TOWN OF CARMEL
PLANNING BOARD

PLANNING BOARD AGENDA
FEBRUARY 22, 2023– 7:00 P.M.

RE: Willow Wood Country Club, Inc.
Amended Site Plan
Union Valley Road
Tax Map No. 87.7-1-6, 7 & 11

Figure 3. Ambient Noise Monitoring Summary for Site LT-1

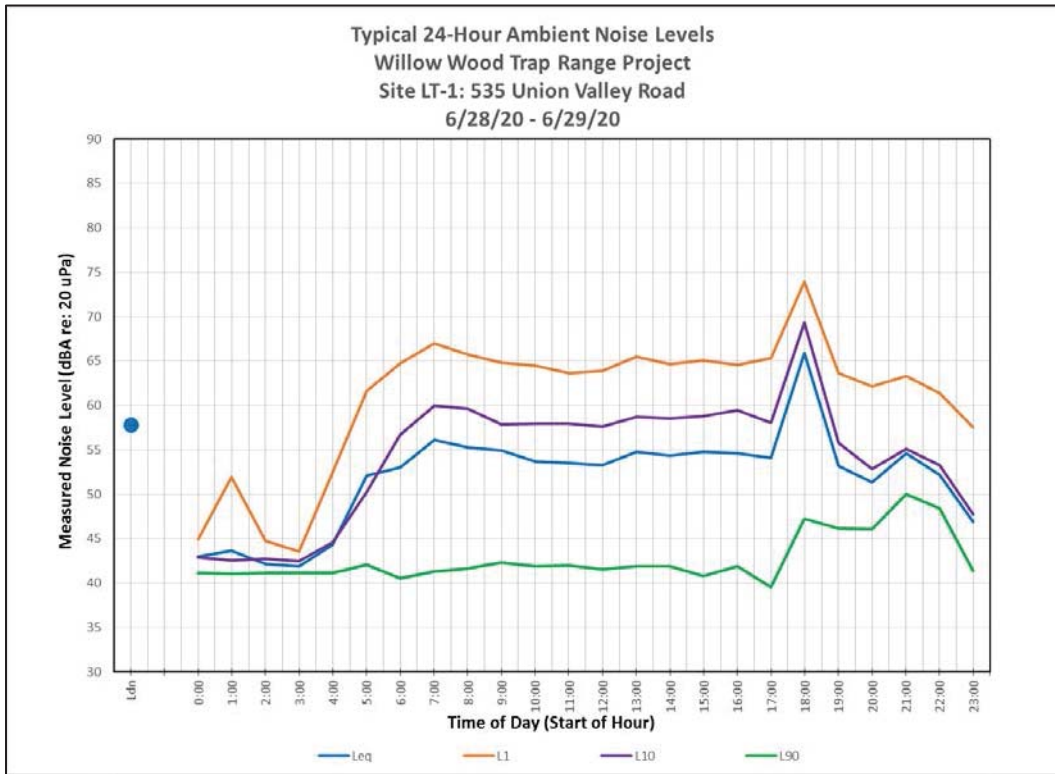
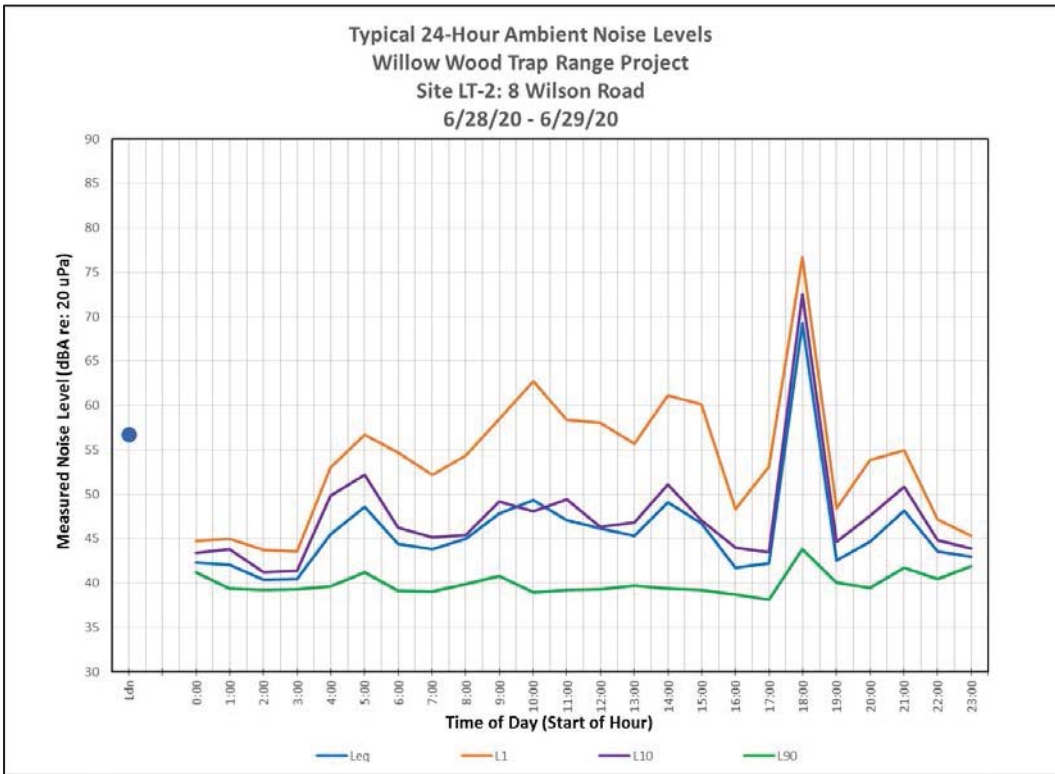
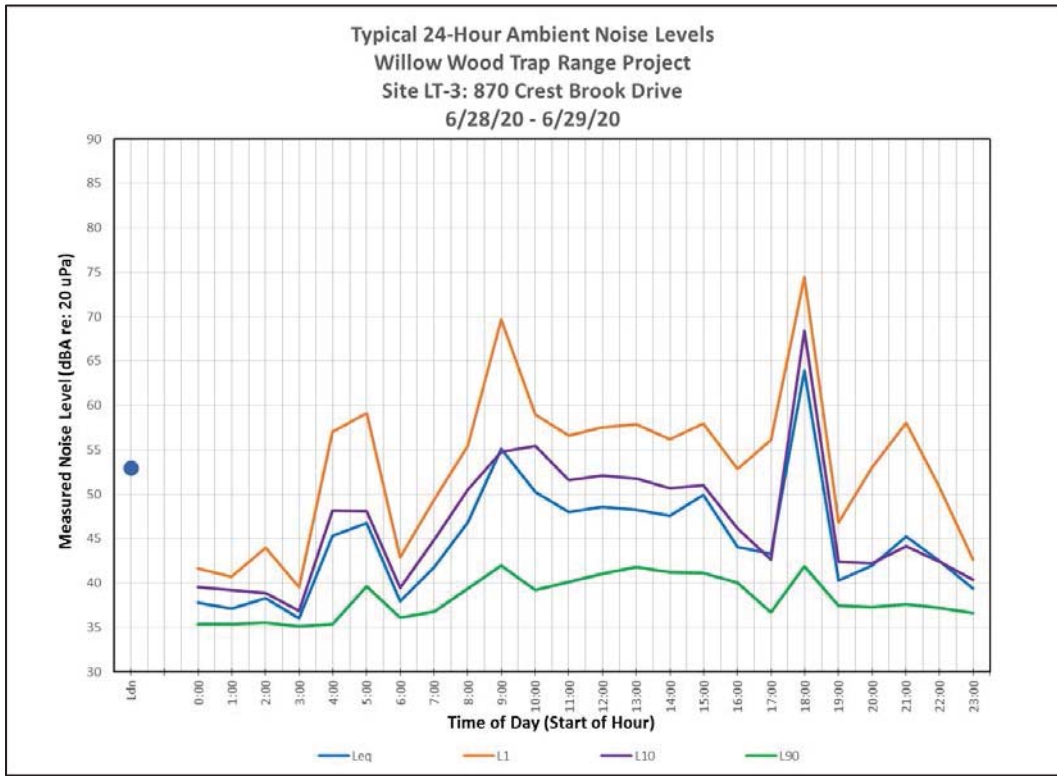
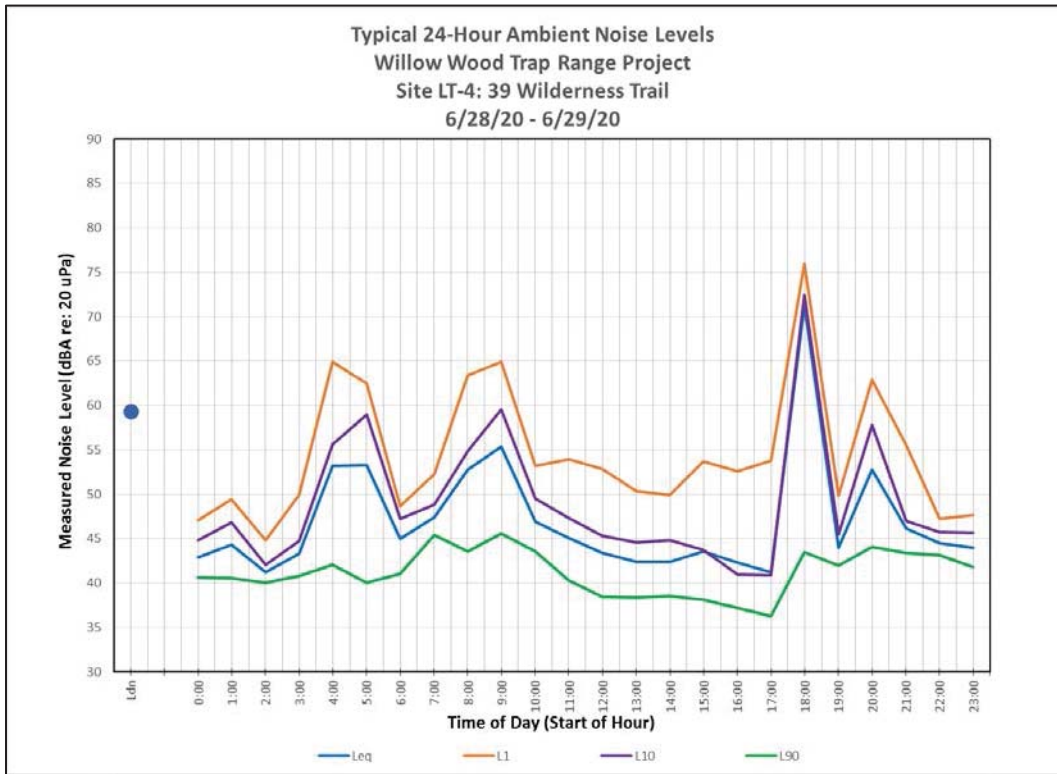
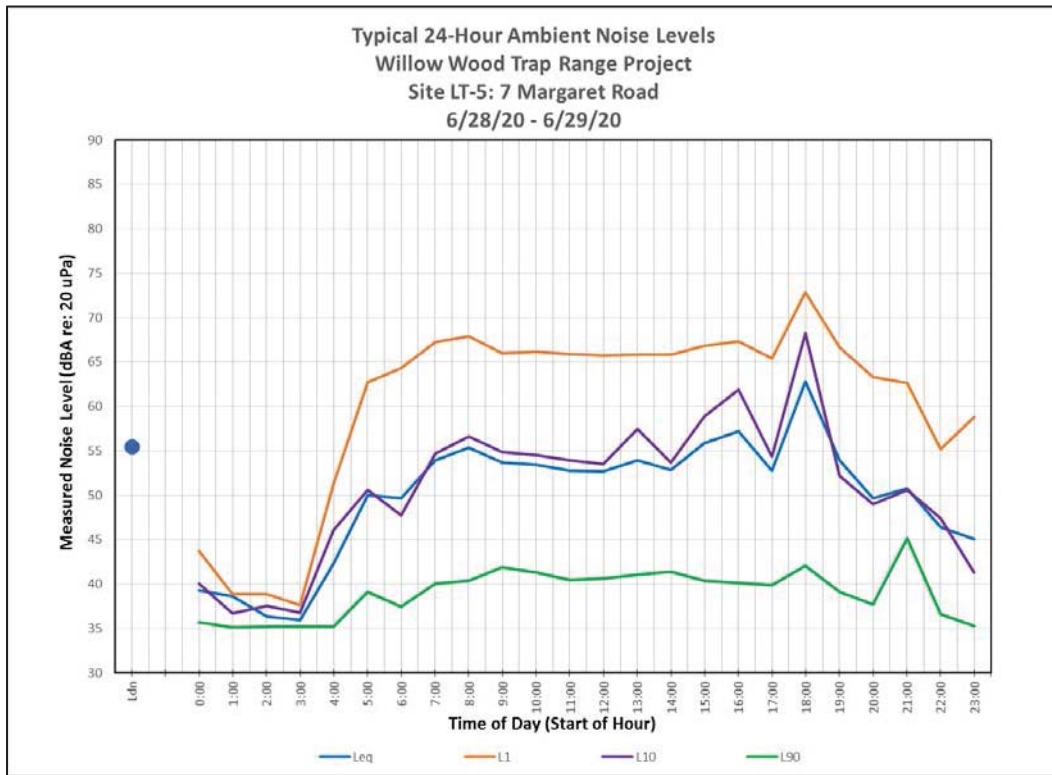
- 3.) *Figures 3 through 7 show a 24-hour period from 0:00 through 24:00, but the titles indicate 6/28-6/29/2020. Please confirm whether this is a continuous period of time and to which date they pertain.*

- a. The long-term ambient noise measurements were performed continuously from 6/28/20 through 6/29/20. Data was stored for each separate hour. The figures show the average results for a given hour of the day or night starting at 00:00 through 23:00.

**Figure 11. 60 dBA Lmax Slow Noise Impact Zone
(Existing Worst-Case Winter Condition)**

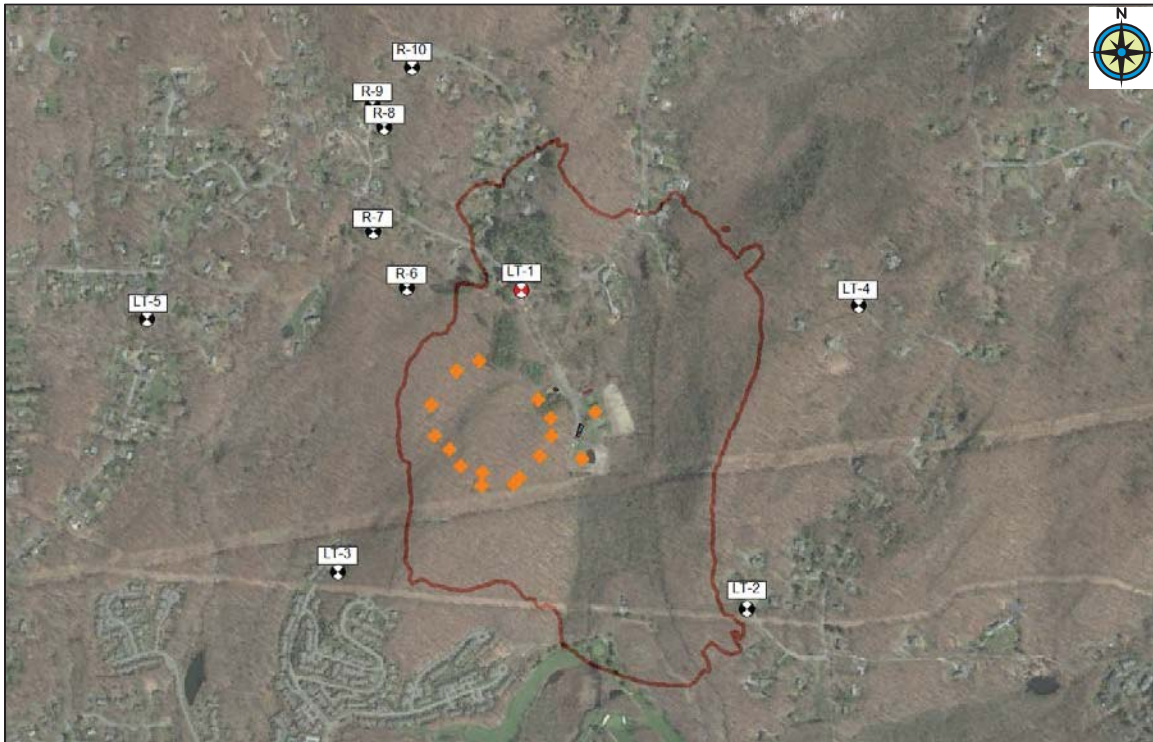
11.) *Table 4 appears to show the loudest gunshot from a specific proposed location during winter conditions at each of the 11 modeled locations, but it is unclear how the "existing worst-case wintertime gunshot noise impact zone" shown in Figure 11 was calculated. Please clarify.*

- a. The noise impact zone shown in Figure 11 was computed using the Cadna-A noise model with 60 dBA being the only isopleth contour selected for display, i.e. the community noise limit in the Carmel Noise Ordinance. All the proposed shooting positions were active in the model because gunshots from different shooting positions project their noise more significantly (i.e. louder) in different directions. Thus, the figure illustrates the worst-case potential noise impact zone in all directions surrounding the club, regardless of which specific shooting position is actually being used.
